**PLANNED UNIT DEVELOPMENT &  
SUBDIVISION STAFF REPORT****Date: March 18, 2004**

**DEVELOPMENT NAME** Treadwell Ford Subdivision

REQUEST Planned Unit Development, Subdivision

# SITE PLAN

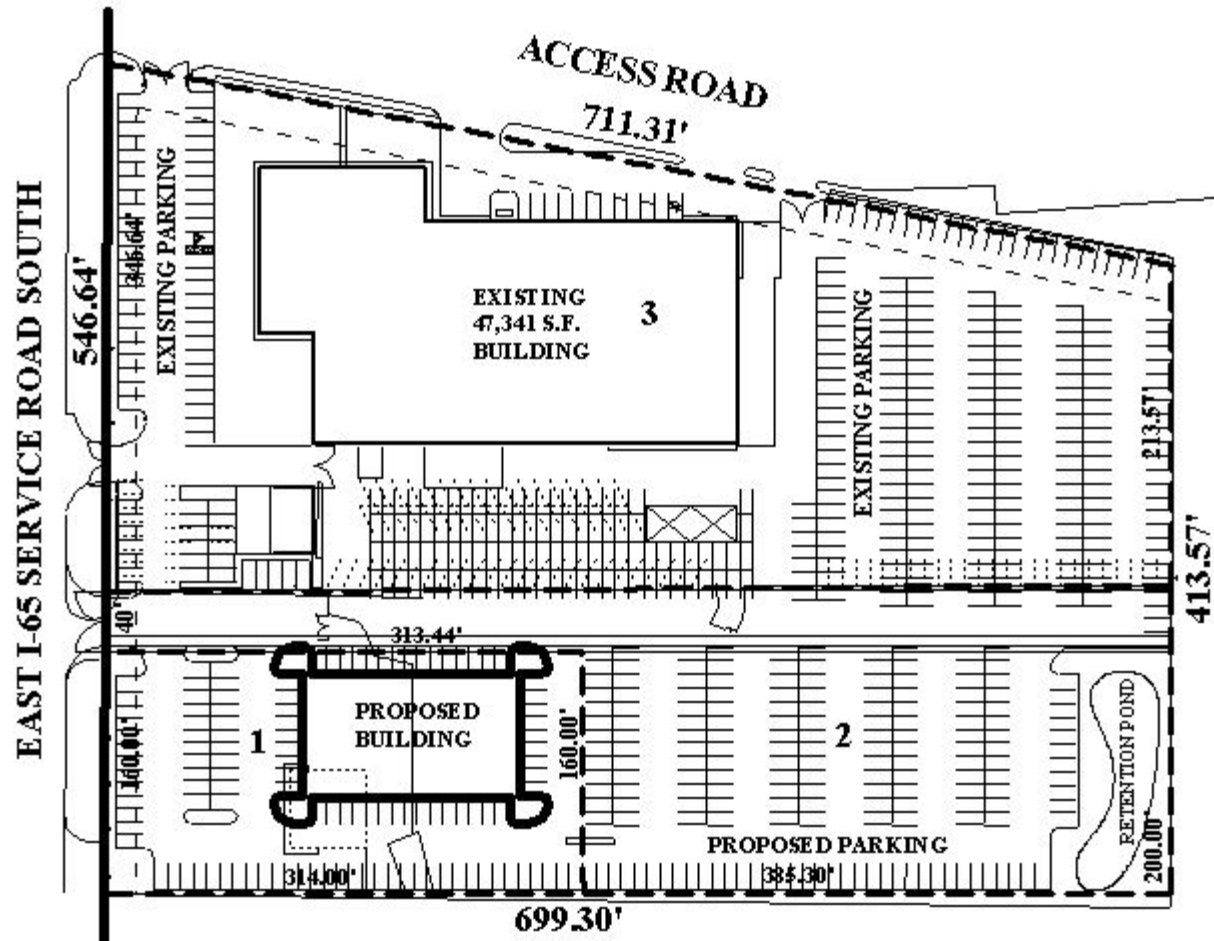
The proposed PUD would allow cross access between the three proposed lots, and an existing access road for Bel Air Mall, which adjoins the property to the North. The site plan illustrate parking spaces on Lot 3 that do not have maneuvering area; however, it is common to park cars in such a manner on a new car lot. Furthermore, excluding the parking spaces that do not have maneuvering area, the overall site provides more than the required number of parking spaces and maneuvering areas. It should be noted that much of the existing parking area is unimproved, and all parking, on all three lots, must be paved.

Lot 1 will be developed with a new building, thus full compliance with the landscaping and tree planting requirements of the Ordinance is required for that lot. There is an existing curb cut located at the Southwest corner of the site that will no longer be used; this curb cut should be closed, back-filled and grassed. As illustrated on the proposed site plan, the number of curb cuts would be reduced; however, the second curb cut to the South will be shifted slightly to the North, leaving only 100-feet between two curb cuts. Both Traffic Engineering and the Alabama Department of Transportation (ALDOT) should approve the location and design of any new curb cuts.

**RECOMMENDATION**      **Planned Unit Development:** Based upon the preceding, this application is recommended for approval subject to the following conditions: 1) full compliance with the landscaping and tree planting requirements for Lot 1, 2) the paving of all parking with asphalt or concrete; 3) that the southernmost, unused, curb cut be closed, back-filled and grassed; 4) that Traffic Engineering and ALDOT approve the location and design for all new curb cuts; and 5) full compliance with all municipal codes and ordinances.

**Subdivision:** With a waiver of Section V.D.3., the plat will meet the minimum requirements of the Subdivision Regulations and is recommended for Tentative Approval subject to the following condition: 1) placement of a note on the final plat stating that Traffic Engineering and ALDOT approval is required for the location and design for any new curb cuts.
